RE: Volvo Recall 216
Certain Model Year 2010 - XC60

<h1 style="margin: 0;">VOLVO</h1> <h2 style="margin: 0;">Service Manager Bulletin</h2>				TITLE:		GROUP:	NO:
				Recall 216: Driver's Seat Side Cover		85	216
Model Year 2010 XC60		ISSUING DEPARTMENT:					
		REFERENCE BULLETINS: PB 85-216 RTJ 22106		Warranty			
DATE: YEAR MONTH DAY 2009 11 20				CARMARKET:			
		Service Personnel: read and initial.		United States, Canada			
SERVICE MANAGER	SERVICE WRITER			WARRANTY ADMINISTRATOR			
Page 1 of 3		<input type="text"/>		<input type="text"/>		<input type="text"/>	
		<input type="text"/>		<input type="text"/>		<input type="text"/>

Recall 216: Driver's Seat Side Cover Panel Modification

Removing the rib material

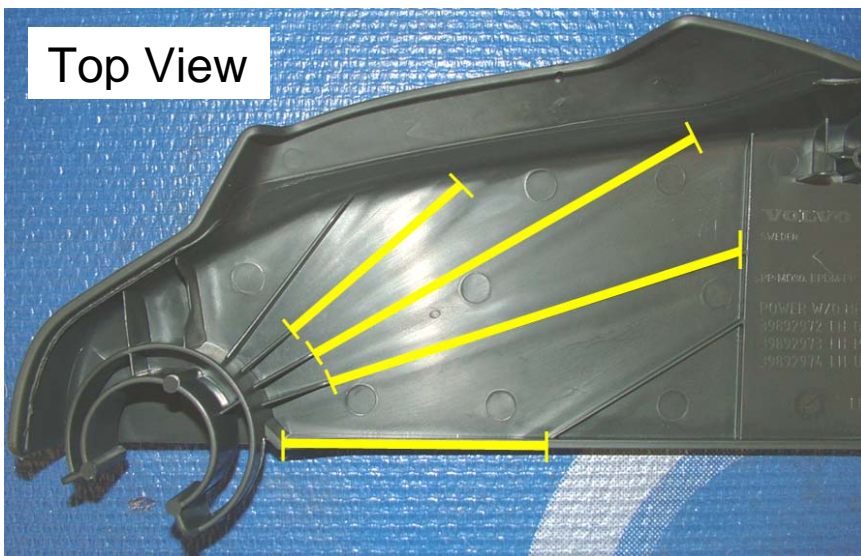
SERVICE: Remove the driver's seat cover panel and with the cover face down on a soft surface remove the panel reinforcement ribs as indicated in the following steps.

When removing the ribs place the cover face down on a protective material so you do not damage/scratch.

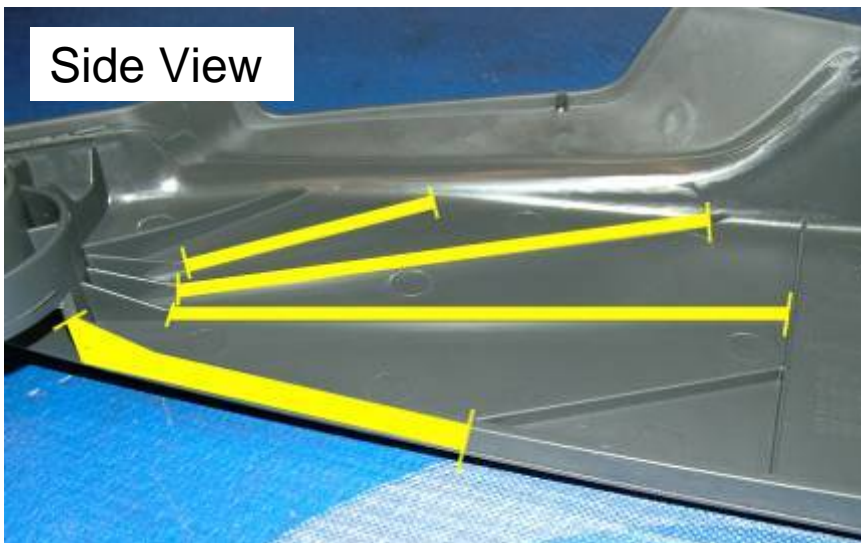
NOTE: Only remove the sections of the four ribs highlighted here. There is no need to remove additional material!

With the end cutting pliers cut off as much of the rib material from the back-side of the panel as possible.

This will reduce the amount of grinding necessary. The intention is to not grind through the panel and require a replacement panel.

After cutting with the end cutters use a small grinding tool to remove the remaining rib material from the back-side of the panel as shown here.
